## Access Compliance Report Public Rights-of-Way (Curb Ramps)

Intersection ID: 27824 Main Street: BALLANTYNE\_CROSSING\_AV Cross Street: TRADING\_PATH\_WY Location: SE

ADA ID: 59D84B010FAD Ramp Type: Perp Initial Pass/Fail: Fail Overall Compliance: No Severity Score: 25

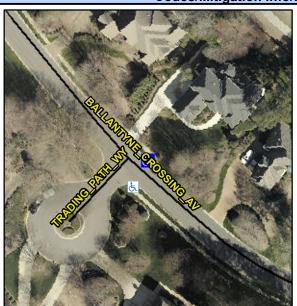
R304.2.2

Compliance Description Data Compliance Description Data No N/A Ramp Length (in) 48.0 Ramp Slope (%) 13.1 Yes Ramp XSlope (%) Yes Ramp Width (in) 48.0 0.0 N/A N/A Flare Type LT N/A Flare Type RT N/A N/A N/A N/A Flare Slope RT (%) N/A Flare Slope LT (%) N/A Flare Traversable LT? N/A N/A Flare Traversable RT? N/A N/A N/A N/A DWS Provided? N/A Landing Length (in) N/A Landing Width (in) N/A N/A **DWS Contrast?** N/A N/A N/A N/A Landing Slope (%) DWS Length (in) N/A N/A Landing X Slope (%) N/A N/A DWS Full Width? N/A N/A Landing Curb? (Y/N) N/A N/A DWS Offset (in) N/A N/A N/A Shared Landing? N/A **Gutter Ponding?** N/A N/A Gutter Slope (%) N/A N/A Gutter Lip Ht (in) N/A N/A Gutter X Slope (%) N/A N/A Painted X Walk1? No N/A Painted X Walk2? N/A X Walk 1 Direction To SW X Walk 2 Direction N/A N/A N/A N/A X Walk 1 Width (in) X Walk 2 Width (in) N/A X Walk 1 Slope (%) 3.3 X Walk 2 Slope (%) N/A X Walk 1 X Slope (%) 2.9 X Walk 2 X Slope (%) N/A N/A N/A N/A Ramp inside XWalk2? Ramp inside XWalk1? N/A Road Slope (%) N/A N/A Clear Space? N/A N/A Road X Slope (%) N/A Clear Space to XWalk (in) N/A N/A N/A Any Obstructions? N/A Storm Grate/Utility Hazard? N/A **Obstruction Type** Storm Grate/Utility Type N/A N/A

Remove & Replace Entire Ramp.
